Planning permission is sought to demolish existing buildings and redevelop the site for mixed, predominantly residential use, with flatted development and retail floor space. At 52 Saughton Mains Gardens Edinburgh EH11 3QE

**Application No:** 20/01318/FUL

**DECISION NOTICE**

**Ground and first floors**

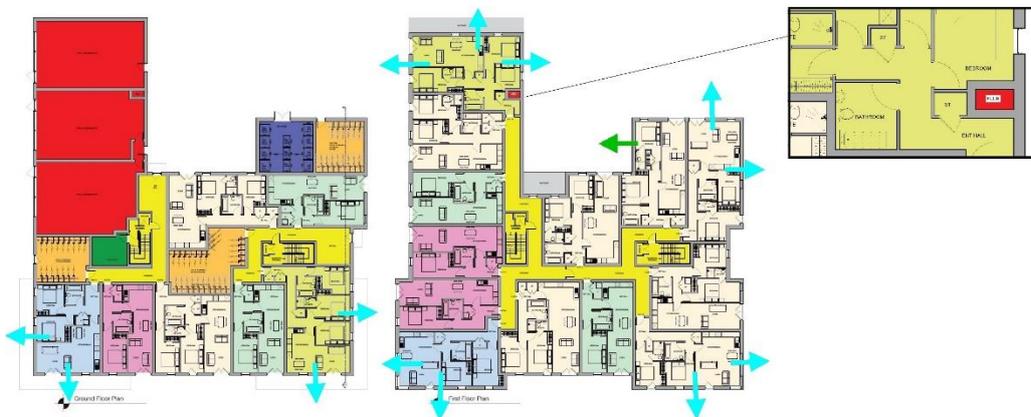
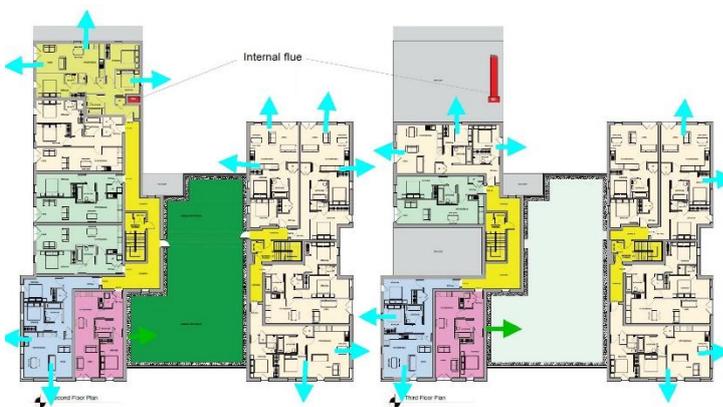
The proposal identifies that of the 38 units, 22 of these would be single aspect flats which represent 57% of the total number of units. Of the single aspect units, 7 of these are also north facing this representing 18% of the total units within the scheme. It is also noted that several of these single aspect units are relatively deep plan in nature, with minimal fenestration. The applicant has not provided information, e.g. Vertical Sky Component analysis to demonstrate whether levels internal daylighting would be achieved.

In summary, the high proportion of single aspect dwellings proposed including the number of north facing units do not satisfactorily address the requirements of the Edinburgh Design Guidance. The failure to provide a Noise Assessment and develop the design proposal to take account of its findings is unsatisfactory.

The number of flats that are single aspect exceed those that are dual aspect, however they have all got open outlooks. There is potential to add dual aspect to three further flats, indicated by the green arrows on the figure below. The blue arrows indicate those flats that are dual aspect. This would increase dual aspect flats to 18, close to 50%.
